TSG-RAN Meeting #11
Palm Springs, CA, U.S.A., 13-16 March 2001

Title: **Agreed CRs to TS 25.430**

CHANGE REQUEST

Title: ⌘	Correction of ALCAP	
Source: ⌘	R-WG3	
Work item code: ⌘		***Date:*** ⌘ January, 2001
Category: ⌘ **F**		***Release:*** ⌘ R99

Figure 7: Iub Interface Protocol Structure.

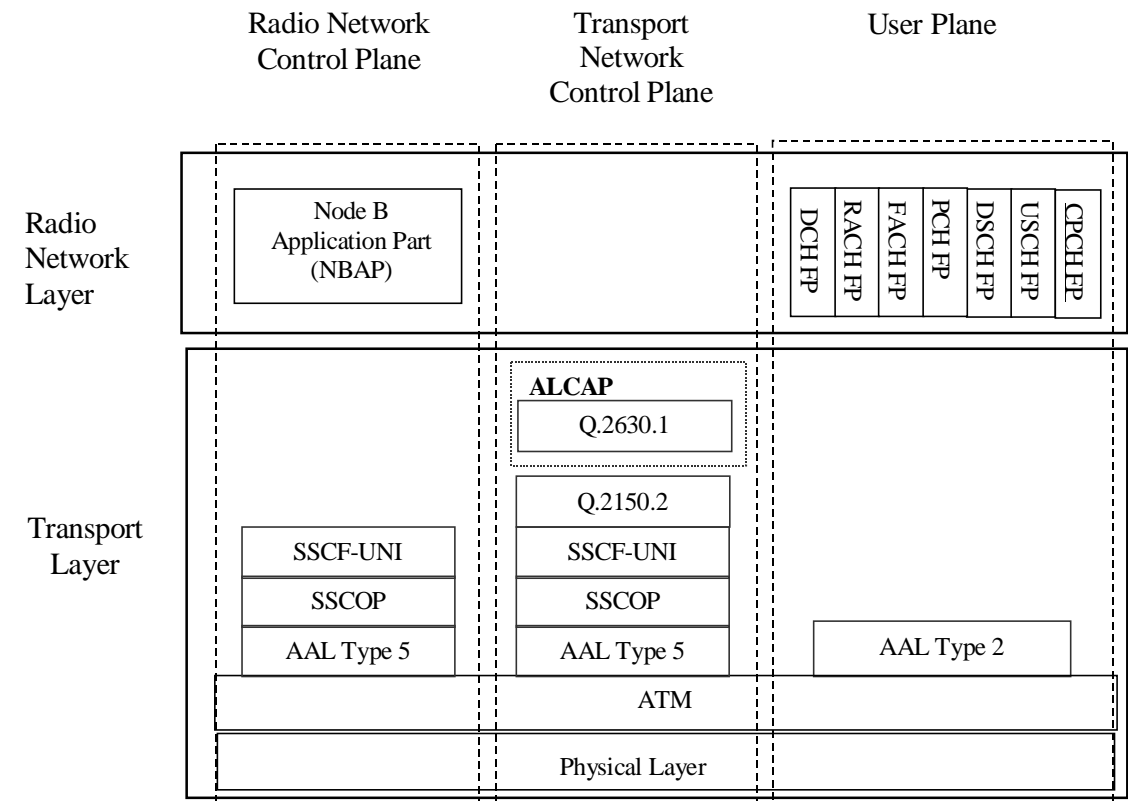
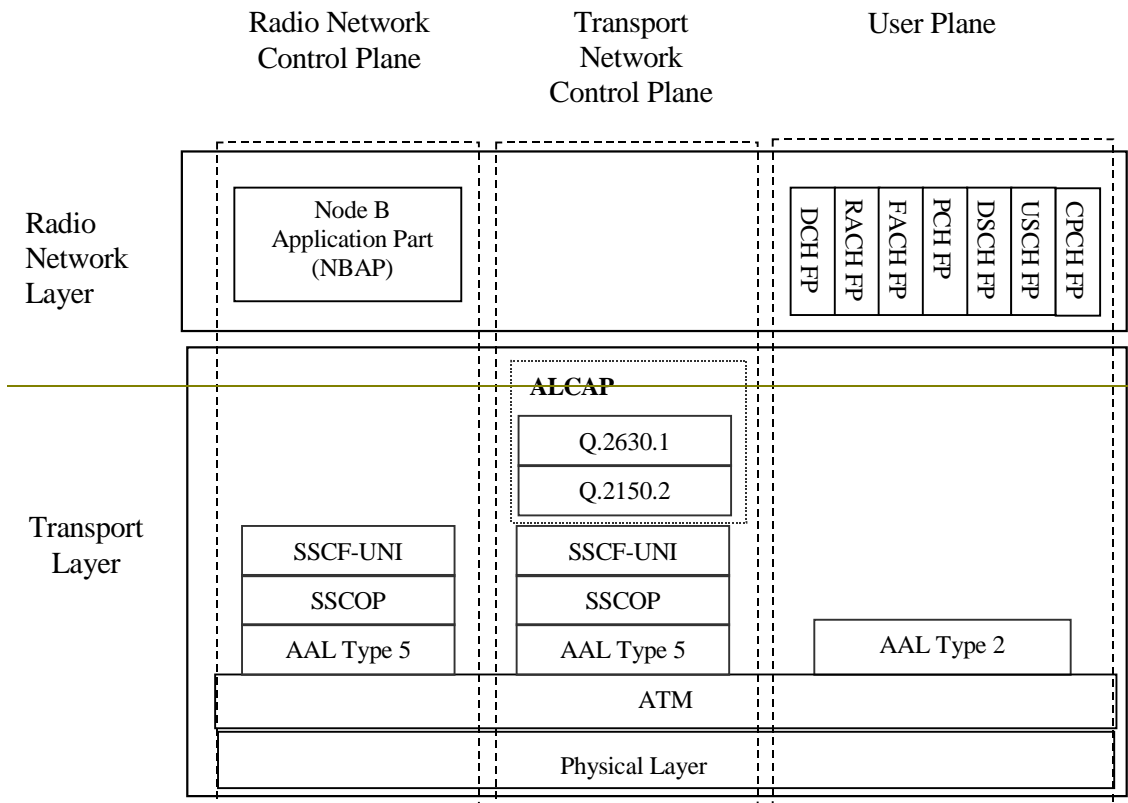
Reason for change: ⌘	In Figure 7, ALCAP consists of Q.2630.1 and Q.2150.2. As ALCAP consists of only Q.2630.1, this CR changes Figure 7.
Summary of change: ⌘	This CR corrects ALCAP in Figure 7.
Consequences if not approved: ⌘	The mistake corrected in this CR will remain.
